**SOLICITATION AMENDMENT
MODIFICATION DE L'INVITATION**

Title - Sujet Focus Pods, Chairs, Whiteboards Focus Pods, Chairs, Whiteboards	
Solicitation No. - N° de l'invitation EP916-212055/C	Amendment No. - N° modif. 002
Client Reference No. - N° de référence du client 20212055	Date 2021-05-07
GETS Reference No. - N° de référence de SEAG PW-\$\$PQ-999-79974	
File No. - N° de dossier pq999.EP916-212055	CCC No./N° CCC - FMS No./N° VME
Solicitation Closes - L'invitation prend fin at - à 02:00 PM Eastern Daylight Saving Time EDT on - le 2021-05-13 Heure Avancée de l'Est HAE	
F.O.B. - F.A.B. Plant-Usine: <input type="checkbox"/> Destination: <input checked="" type="checkbox"/> Other-Autre: <input type="checkbox"/>	
Address Enquiries to: - Adresser toutes questions à: MacCuaig, Shannon	Buyer Id - Id de l'acheteur pq999
Telephone No. - N° de téléphone (613) 697-0956 ()	FAX No. - N° de FAX () -
Destination - of Goods, Services, and Construction: Destination - des biens, services et construction:

Amendment 002 is raised to:

File no.: EP916-212055 /C
Project: NSERC Zibi - Block 211 - PSPC Fit-Up

Diagram for Q9: - R4

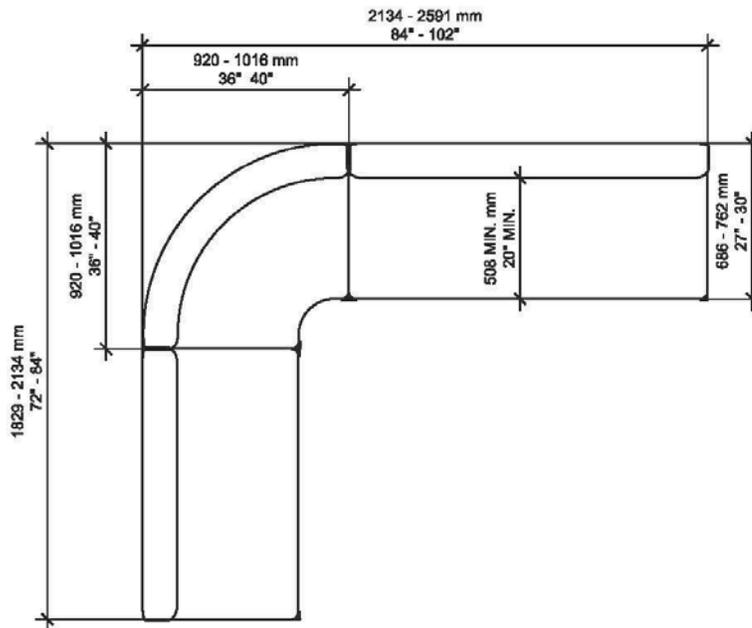
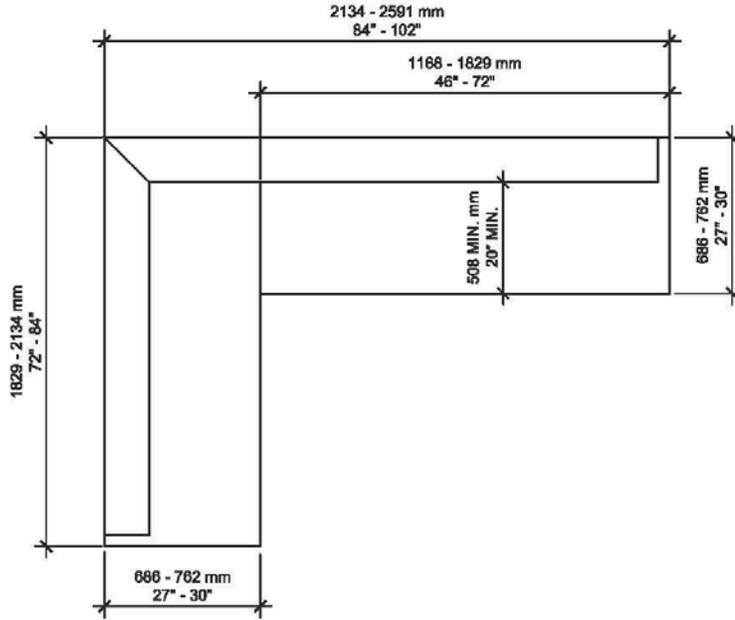
Q16 R4 – L-shaped seating ; would it be possible to provide the total width x total depth of the sofa? It is unclear to me whether 4.2.1 if the overall width of 46-59" mentioned is the dimensions for a straight piece only, or with the inclusion of the corner piece as well?	Q16 R4 - Sièges en forme de L ; serait-il possible de fournir la largeur totale x la profondeur totale du canapé? Il n'est pas clair pour moi 4.2.1 si la largeur totale de 46 po-59 po mentionnée est les dimensions pour une pièce droite seulement, ou avec l'inclusion de la pièce de coin aussi?	002
A16 Please see diagram that was provided with A9	R16 Veuillez consulter le schéma fourni avec A9	002
Q17 R4 – L-shaped seating 4.2.4 would the customer accept a depth of 33.8" vs the 37-40" requested?	Q17 R4 - Sièges en forme de L 4.2.4 - Le client accepterait-il une profondeur de 33,8" au lieu de 37-40" comme demandé?	002
A17 With respect to the corner unit, a depth of 33.8" is acceptable as long as the corner piece will still accommodate someone sitting in it. The inside radius of the corner unit must accommodate a user.	R17 En ce qui concerne l'unité de coin, une profondeur de 33.8 po. Est acceptable tant que la pièce de coin pourra encore accueillir quelqu'un assis. L'intérieur de l'unité de coin doit accueillir un utilisateur.	002

Q18 R4 – L-shaped seating 4.2.5 would the customer accept a depth of 22.6" vs the +/- 20" ?	Q18 R4 - Sièges en forme de L 4.2.5 - Le client accepterait-il une profondeur de 22,6 po au lieu de +/- 20 po?	002
A18 20" +/- is a minimum so 22.6" is acceptable.	R18 20 po. +/- est un minimum donc 22.6 po. Est acceptable.	002
Q19 R8 – Focus Pod Desk w. Screens 8.2.2 would the customer accept an overall depth of 65.3" vs. 66-76"?	Q19 R8 - Bureau individuel avec cloisons acoustiques 8.2.2 - Le client accepterait-il une profondeur totale de 65.3 po au lieu de 66-76 po ?	002
A19 Yes, 65.3" is acceptable.	R19 Oui, 65.3 po. est acceptable	002
Q20 R8 – Focus Pod Desk w. Screens 8.2.4 would the customer accept an overall work surface depth of 25" vs. the 27-37" ?	Q20 R8 - Bureau individuel avec cloisons acoustiques 8.2.4 - Le client accepterait-il une profondeur totale de la surface de travail de 25 po au lieu de 27-37 po?	002

See additional dimension sketch after questions.	Voir l'esquisse de cote supplémentaire après les questions.	
Q10: Re: R6, item 6.3.2 Please confirm that a wood frame which meets the design intent is acceptable.	Q10: Re : R6, article 6.3.2 Veuillez confirmer qu'une structure en bois qui se confirme à l'intention de conception est acceptable.	002
A10: Yes, this is acceptable.	R10: Oui, c'est acceptable.	002
Q11: Re: R7, item, 7.2 Please confirm that an overall width of 53" and an overall height of 55" is acceptable	Q11: Re : R7, article 7.2 Veuillez confirmer qu'une largeur totale de 53 po et une hauteur totale de 55 po sont acceptables.	002
A11: Yes an overall width of 53" is acceptable. No, an overall height of 55" is not.	R11: Oui, une largeur totale de 53" est acceptable. Non, une hauteur totale de 55" ne l'est pas.	002
Q12: Re: R8, item 8.2 Please confirm that an overall height of 55" and a worksurface depth of 24" is acceptable.	Q12: Re : R8, article 8.2 Veuillez confirmer qu'une hauteur totale de 55 po et une profondeur de surface de travail de 24 po sont acceptables.	002

1.B.2 Dimension

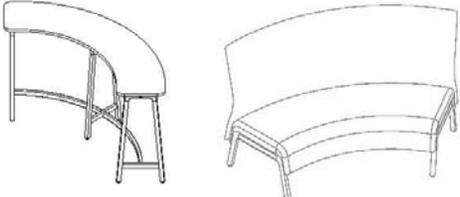
Q23 1.B.2 Dimension .4, would the customer accept a seat depth of 20.25” vs. the 18-20” range?	Q23 1.B.2 Dimension .4, le client accepterait-il une profondeur de siège de 20,25" au lieu de la gamme 18-20" ?	002
A23 Yes. As per item 1.B.2.4 “Seat depth must be no less than 483 mm (19 in.) +/- 25 mm (1 in.) inclusive”	R23 Oui. Conformément à l'article 1.B.2.4 " La profondeur du siège doit mesurer au moins 483 mm (19 po) +/- 25 mm (1 po) inclusivement".	002
